**Comanche Peak Nuclear Power Plant, Units 3 & 4
COL Application**

Update Tracking Report

Title: Comanche Peak Nuclear Power Plant Units 3 and 4 Quality Assurance Program Description

Revision ~~0-1~~2

Figure II.1 Luminant
Organization

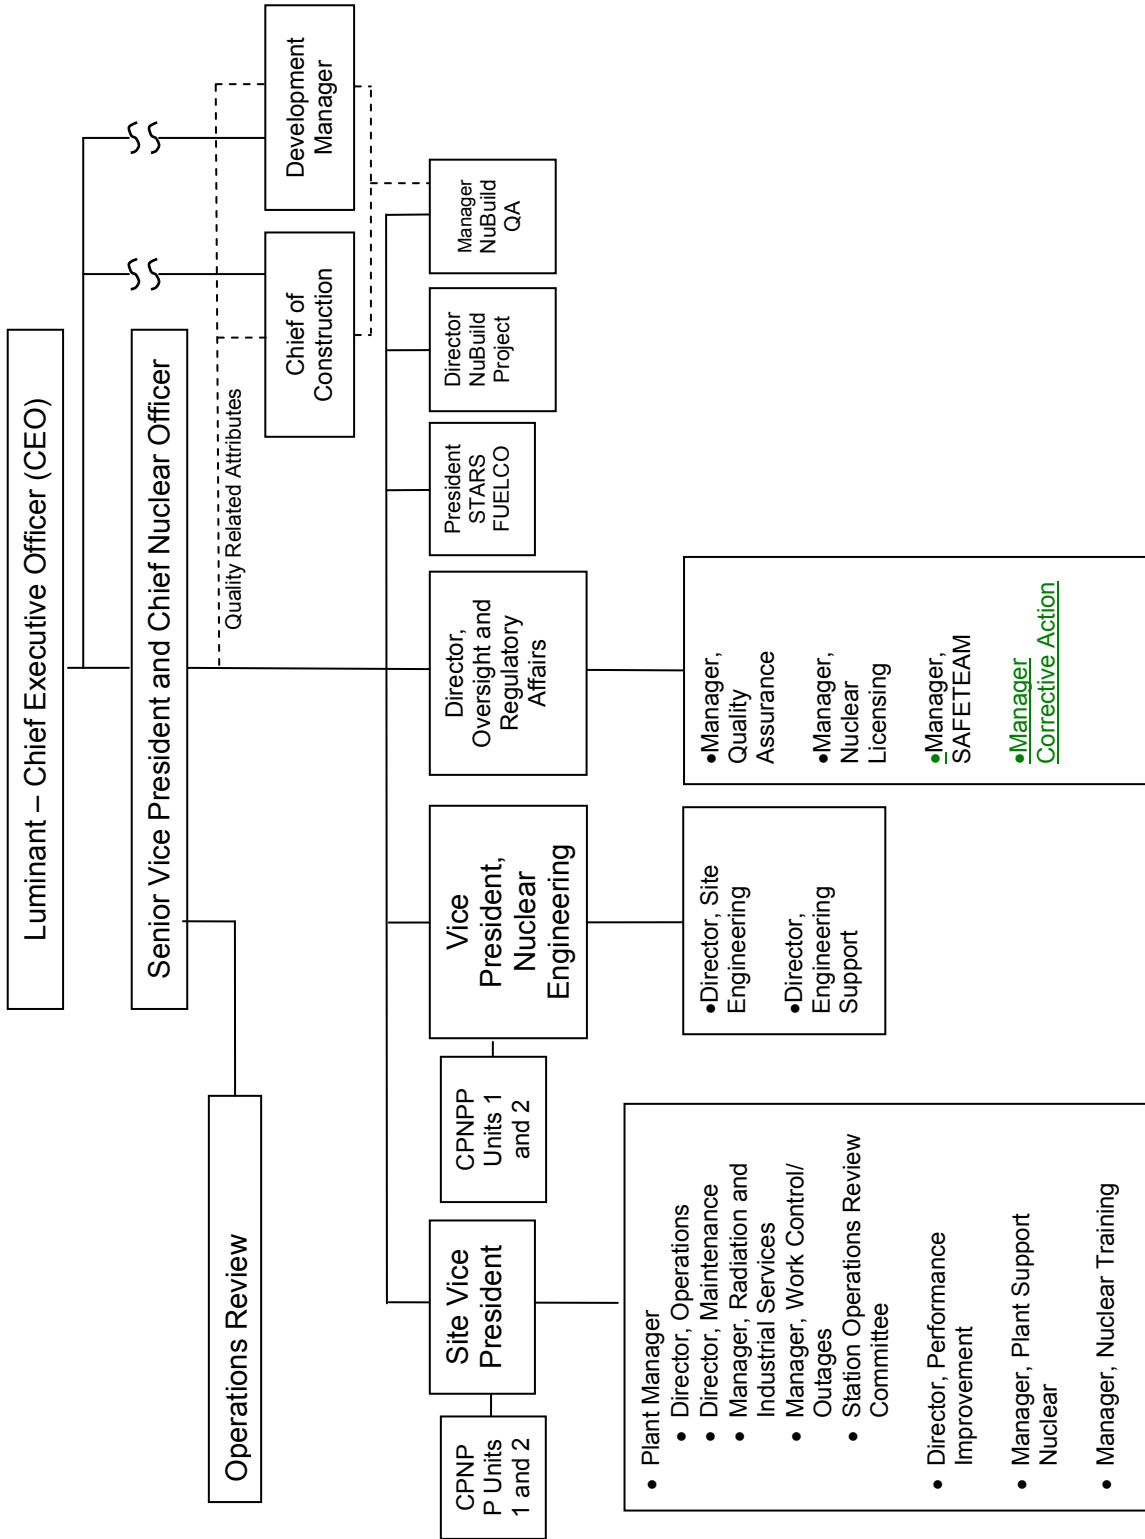
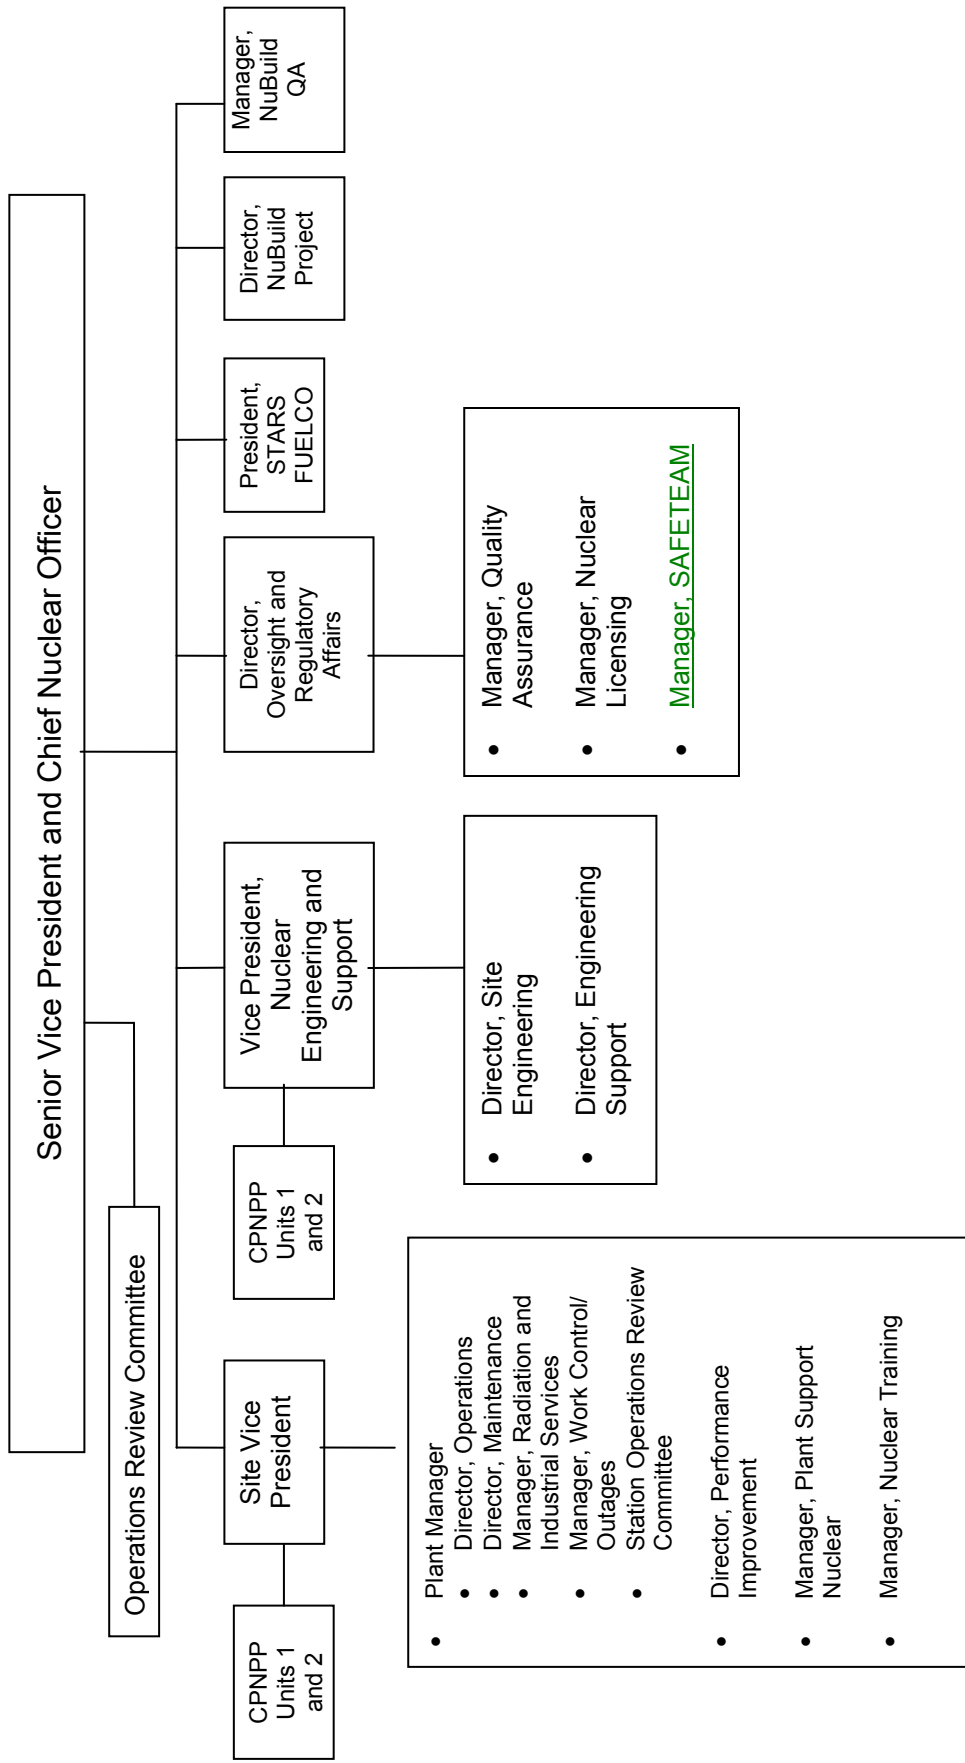
CTS-
01129

CTS-
01129

Figure II.1.1-2
CPNPP Units 3 and 4 Site Organization

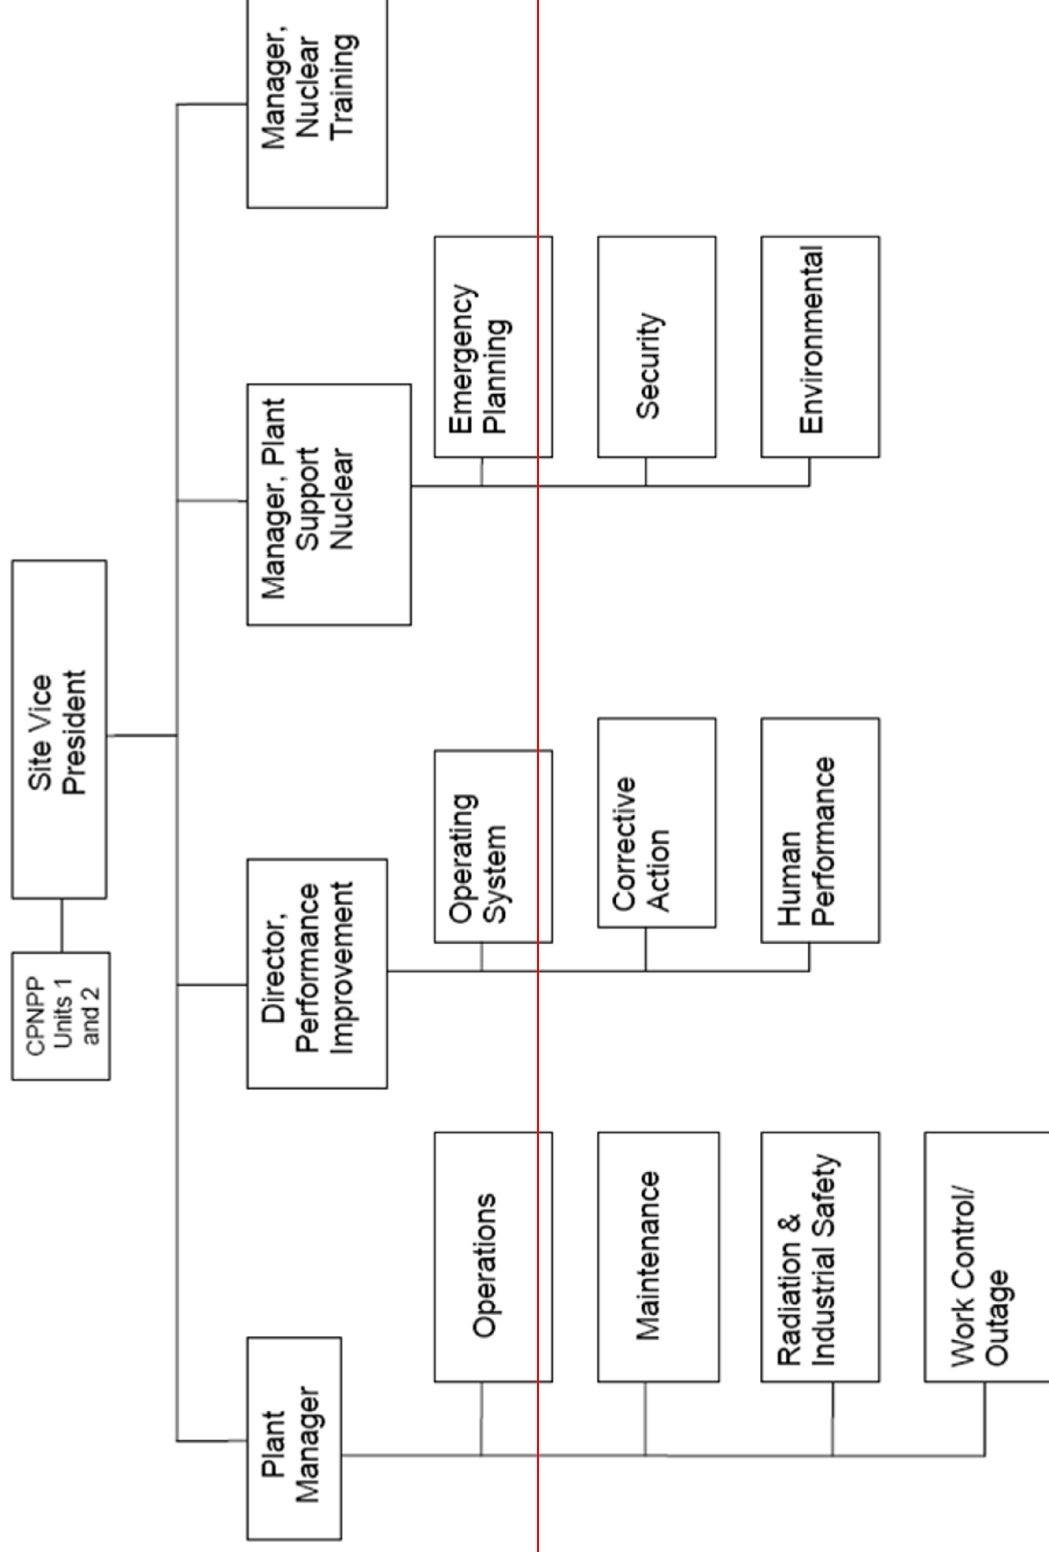
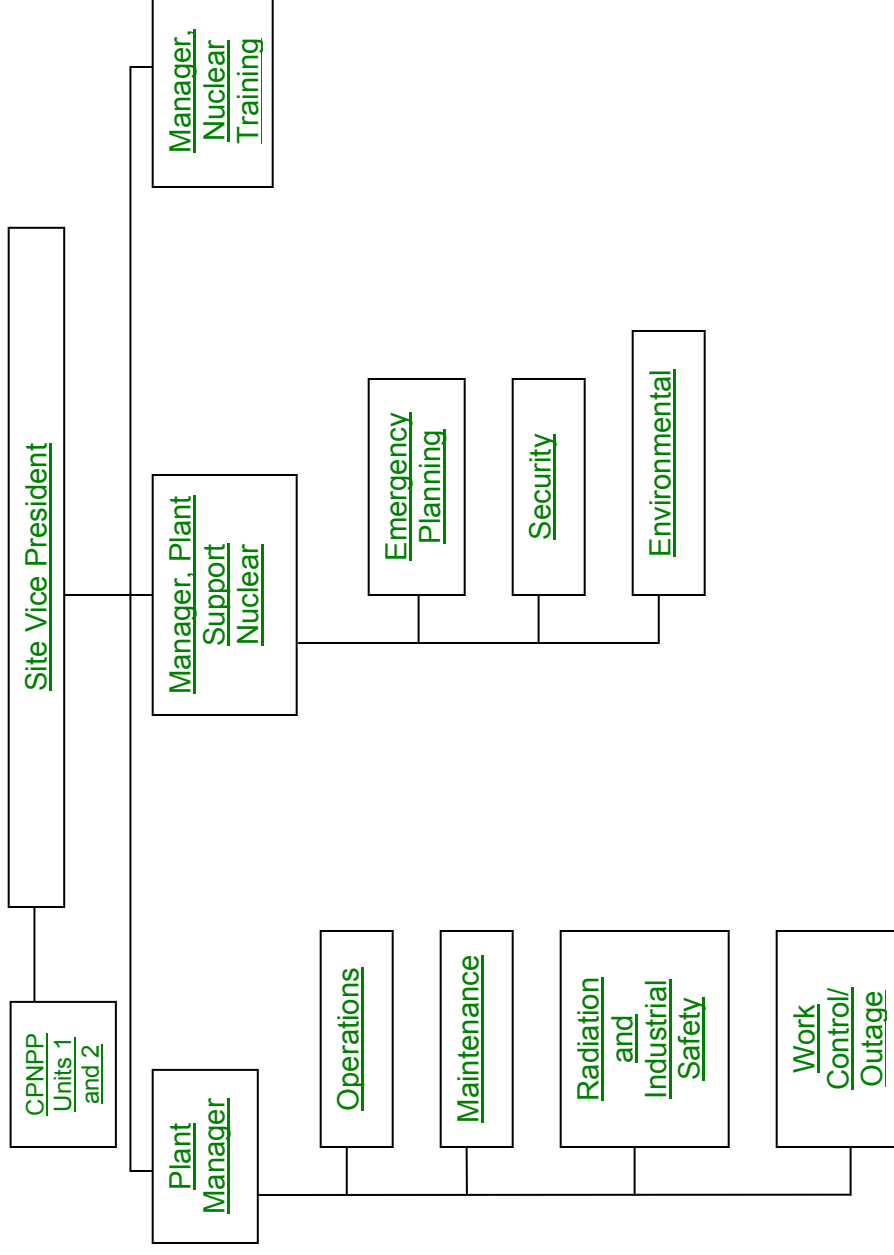
CTS-
01129

Figure II.1.1-3
CPNPP Units 3 and 4 Support Organization

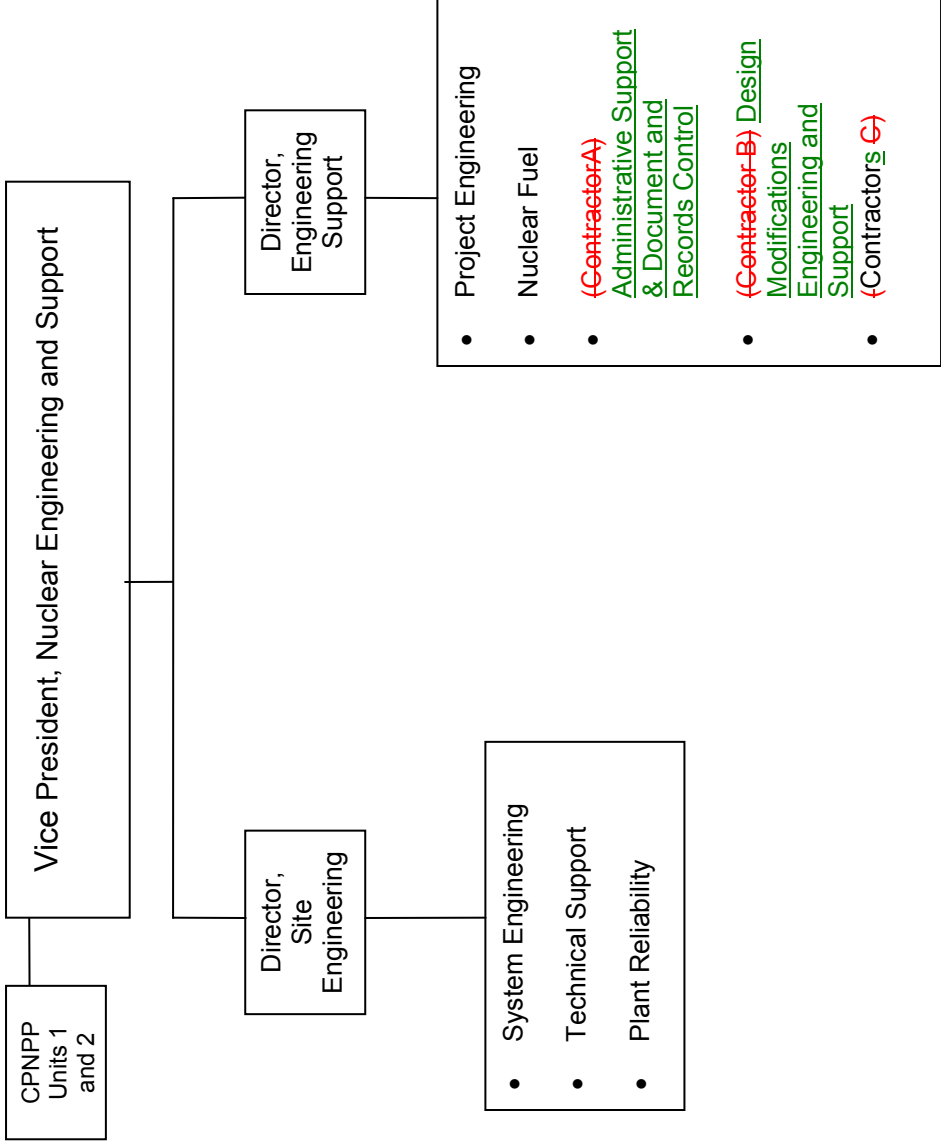
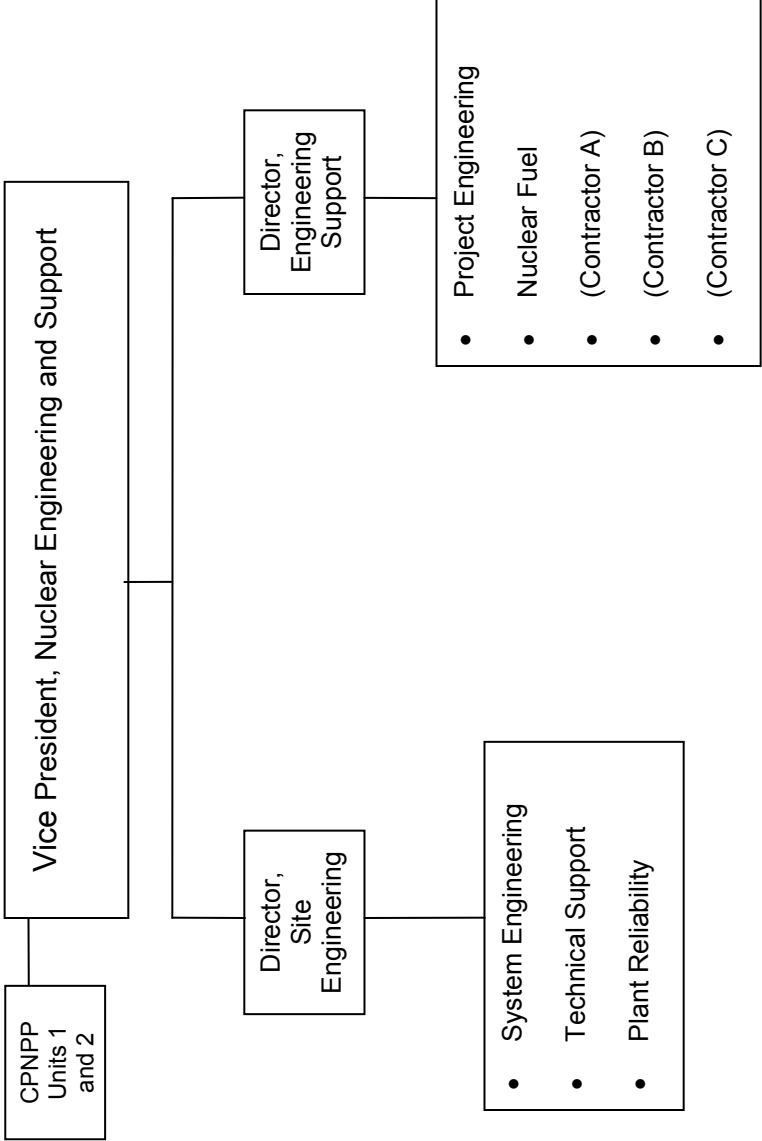
CTS-
01129

CTS-
01129
